**LACH- September 11, 2019 – Comments on the HIA for 1-3 Bathurst Street and 269-281 Thames Street**

Comparison of 1855 and 1892 drawings, Rev. 1907 FIP

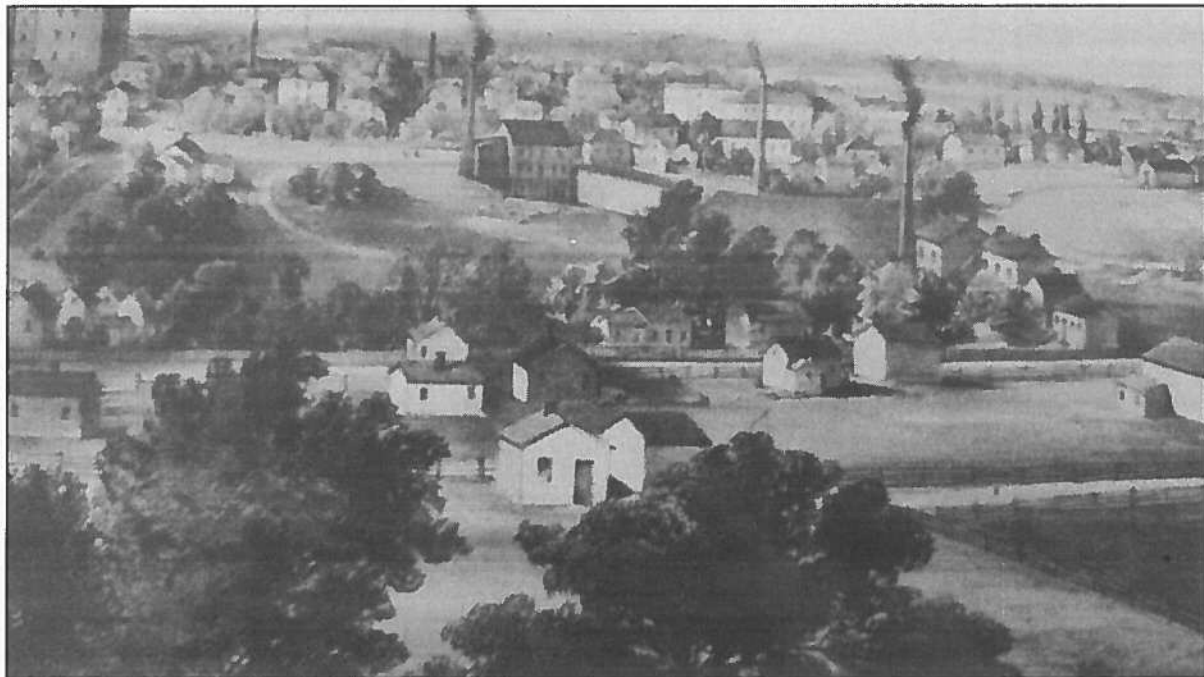
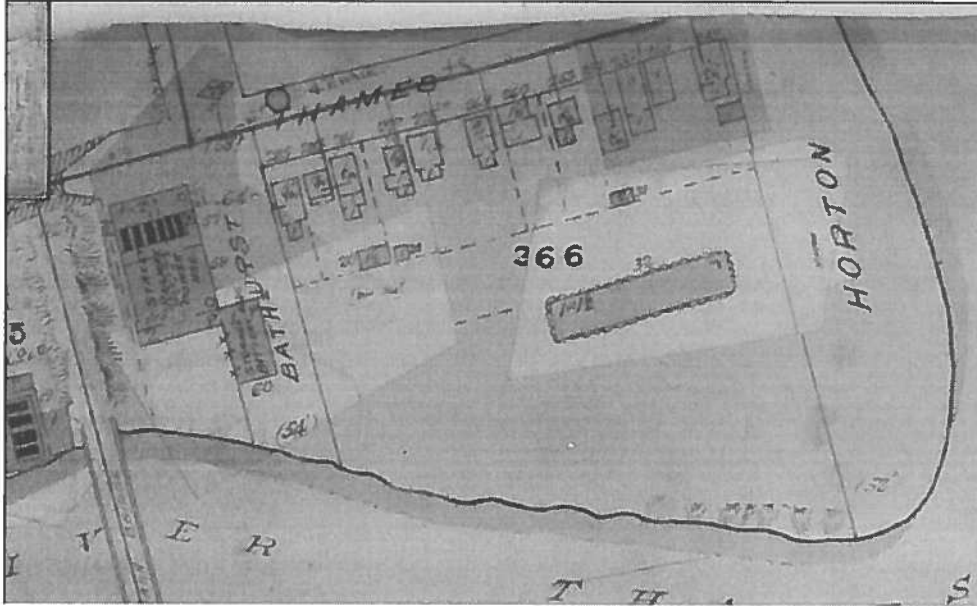
Comment: It is important to document the land use history fully and completely at this stage in the HIA since it may frequently be referenced in future development plans, road improvement plans, etc., especially if there is a possibility a remaining building is related to the Underground Railroad era.

269- already removed

263 - The 1855 drawing demonstrates that the house was likely present as seen with the small single storey addition at the rear (Whitefield, 1855). \*This corresponds to the footprint of the house numbered 263 on the 1892, Revised 1907 FIP (which should be added to the HIA).

- Note the current aerial view of the house may show where the previous small rear addition was present.

267- This house is present by 1907 as shown in the 1892, Revised 1907 FIP. It is likely a mid to late 19<sup>th</sup> century building. It is not likely depicted in the 1855 painting.

257- The 1892, Revised 1907 FIP is important since I believe it demonstrates that the rear of 257 (single storey) is older than the front of the house. The 1922 FIP illustrates the house is long and aligned with 263. This single storey may have been set back as shown in 1892, since a previous farmhouse was removed, as depicted in the 1855 painting.

1. Update report to include these graphics
2. Update report to state that 263 may be an earlier building related to the Hollow. This includes Reg. 9/06 to be amended (meets 2.i)
3. Include the earliest depiction of the rail in 1853 (below)

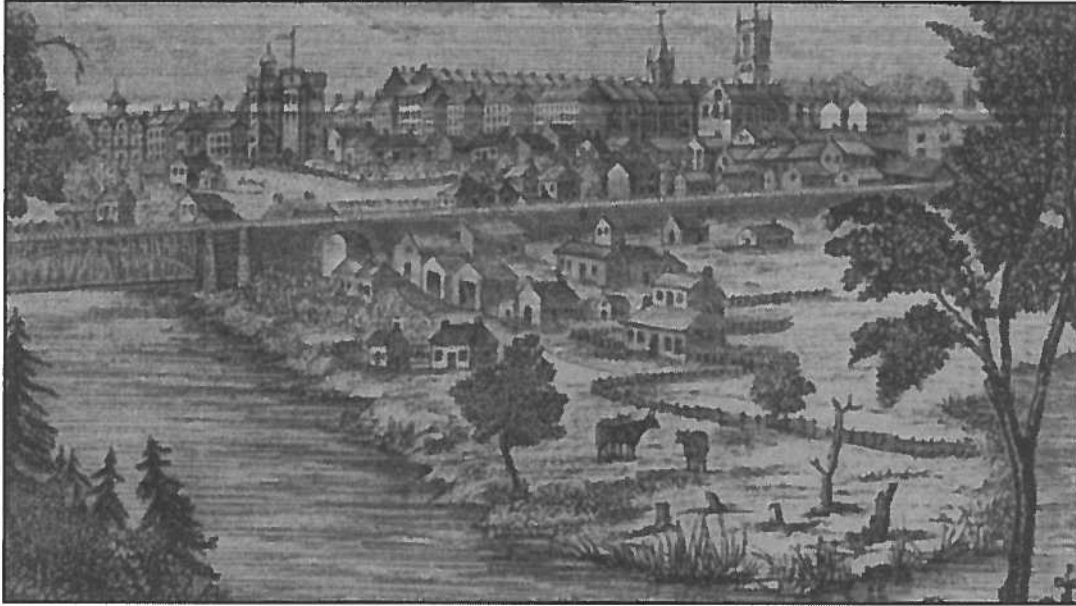
267- built post Underground Railroad era

263- is likely mid-19<sup>th</sup> century and therefore was erected about the same time as the Chapel.
